GULMOHAR RESIDENCY

Details of Additions & Alterations

Flat No	508	Block no.	' D ' ✓
Flat Area	1660 sft	Type	Deluxe / Luxury
Buyer Name	SREENIVAS MEENAKSHI SUNDARAM		
Phone No.	9849935880 6309396875	Email

Description	Direction	Owners & Developers :	Date :	Promoted by
PLUMBING PLAN-1660 Sft (B1-TYPE)	N	Modi Reality Mallapur LLP	04.09.20	Modi Properties Pvt Ltd
		Project Name & Phase :	Prepared By :	
		Gulmohar Residency	Approved By :	
			Scale :	Phone: +91-40-66335551

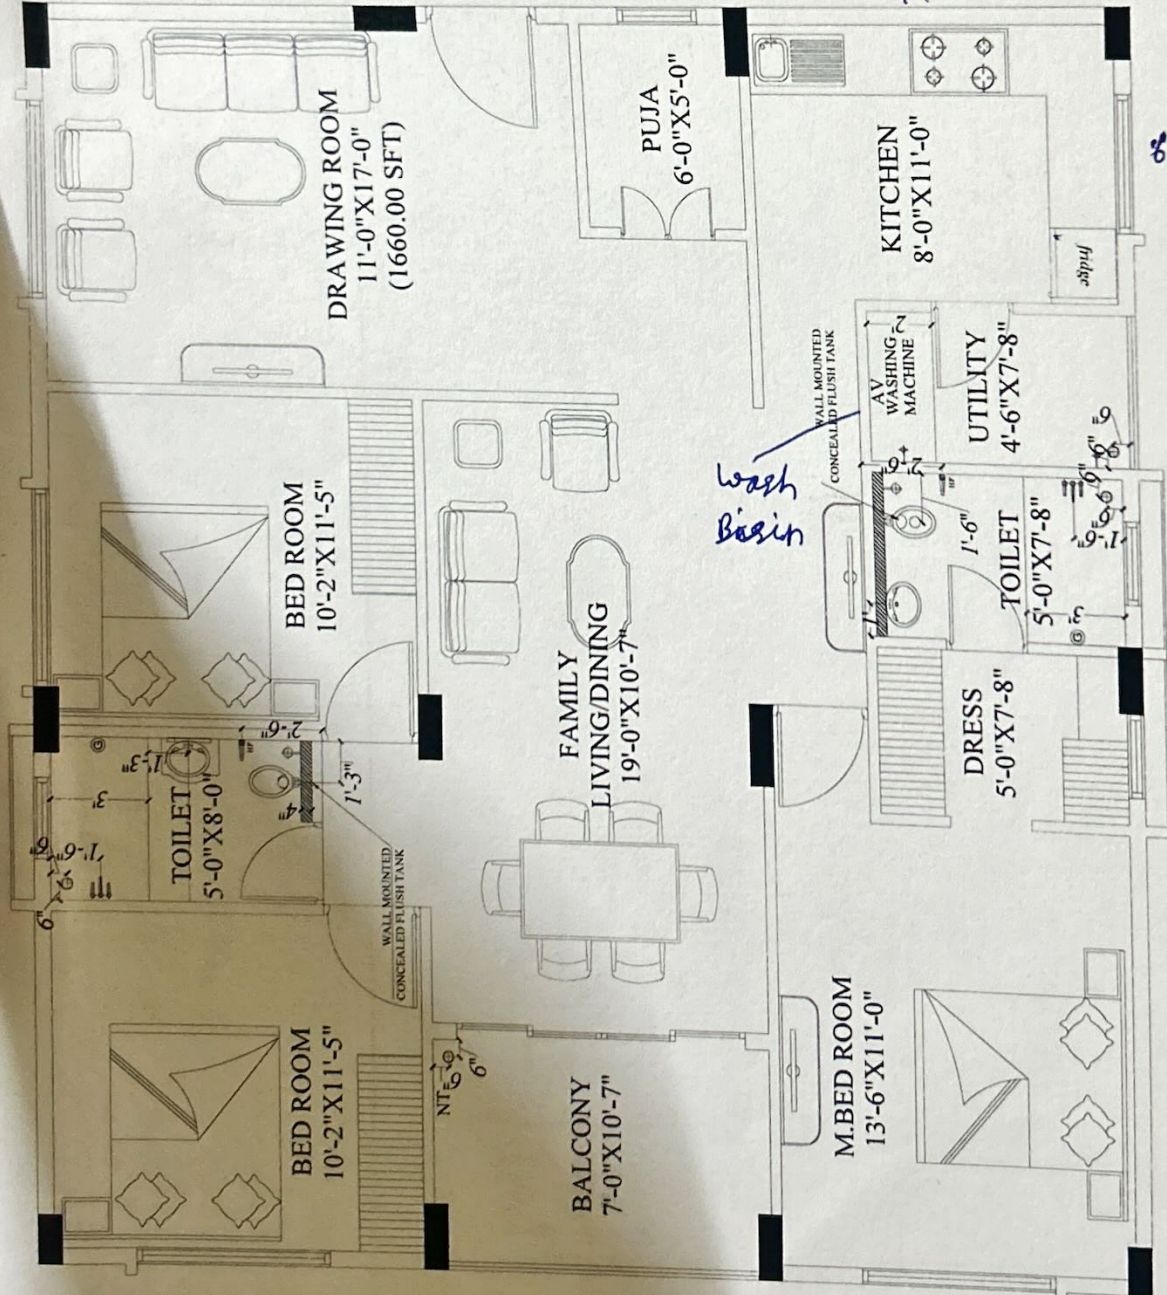
1) need Full platform in kitchen

1) Brick work changes as per Drawing.
